Project	<b>IEEE 802.16 Broadband Wireless Access Working Group</b> < <a href="http://ieee802.org/16">http://ieee802.org/16</a> >	
Title	<b>Correction of inconsistencies for 802.16-2004 OFDMA symbol clock frequency tolerance</b>	
Date Submitted	<b>2005-03-11</b>	
Source(s)	Juergen Otterbach Joerg Schaepperle Roland Muenzner Torsten Fahldieck Alcatel SEL AG	Voice: +49-711-821-32255 Fax: +49-711-821-32453 <a href="mailto:juergen.otterbach@alcatel.de">juergen.otterbach@alcatel.de</a>
Re:	Response to the call for comments IEEE 802.16-2004/Cor1-D1 Corrigendum to IEEE 802.16-2004	
Abstract	Correction of inconsistencies for 802.16-2004 OFDMA	
Purpose	Resolving ambiguity in OFDMA PHY layer §8.4	
Notice	This document has been prepared to assist IEEE 802.16. It is offered as a basis for discussion and is not binding on the contributing individual(s) or organization(s). The material in this document is subject to change in form and content after further study. The contributor(s) reserve(s) the right to add, amend or withdraw material contained herein.

# Correction of inconsistencies for 802.16-2004 OFDMA symbol clock frequency tolerance

Figure 2: Signal-to-interference ratio (SIR) as a function of the absolute tolerance of the sampling clock  $F_s$  in percent of the subcarrier spacing  $\Delta f$

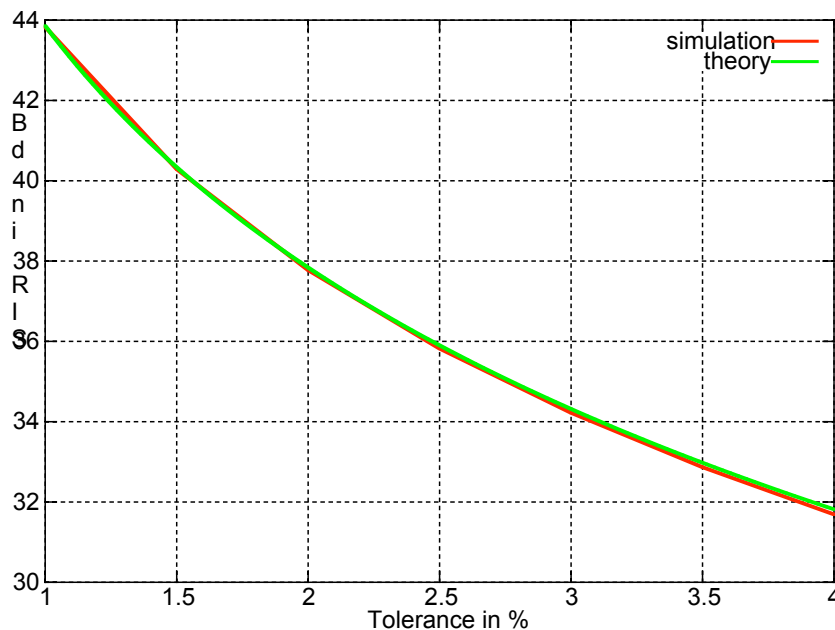
As an indication Figure 2 shows the resulting SIR values in function of the tolerance for the sampling clock frequency for a range of values, that still would leave some margin to the SNR requirement of 24.4 dB for 64 QAM.

A symbol clock frequency tolerance of 2 % of the subcarrier spacing on the other hand, as currently required in 802.16-REVd/D5, results due to the above relation between the symbol clock and the sampling clock frequency in a much higher tolerance for the sampling clock frequency. Therefore this requirement on the symbol clock frequency is not sufficient.

Even though a tolerance of the symbol clock frequency accuracy derived from the range of values for the sampling clock frequency shown in Figure 2 could be sufficient, there is a more direct means to guarantee a still higher accuracy exploiting the requirement that the symbol clock frequency and the center frequency are derived from a single reference at the BS and thus have a fixed and predefined ratio within the system.

At the SS, the transmitted center frequency ~~and the symbol clock frequency~~ shall be synchronized to the BS with a tolerance of maximum 2% of the subcarrier spacing. Additionally the symbol clock frequency at the SS shall be locked to the center frequency at the SS which guarantees a relative tolerance for the symbol clock frequency at the SS of maximum  $0.02 * (\text{subcarrier spacing}) / (\text{center frequency})$ .
